WIRING INSTRUCTIONS FOR REPLACING OLDER MSC-C (PCB VERSION)

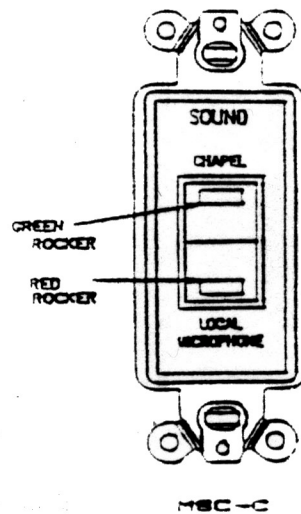
Wire from Terminal 5 – connect to both yellow wires on new MSC-C

Wire from Terminal 4 – connect to both black wires on new MSC-C

Wire from Terminal 3 – connect to green wire on new MSC-C

Wire from Terminal 2 – connect to orange wire on new MSC-C

Wire from Terminal 1 – connect to both red wires on new MSC-C

Green - Sw. Up
Yellow - Sw. Common
Orange - Sw. Down
Red - +24VDC
Black - Ground
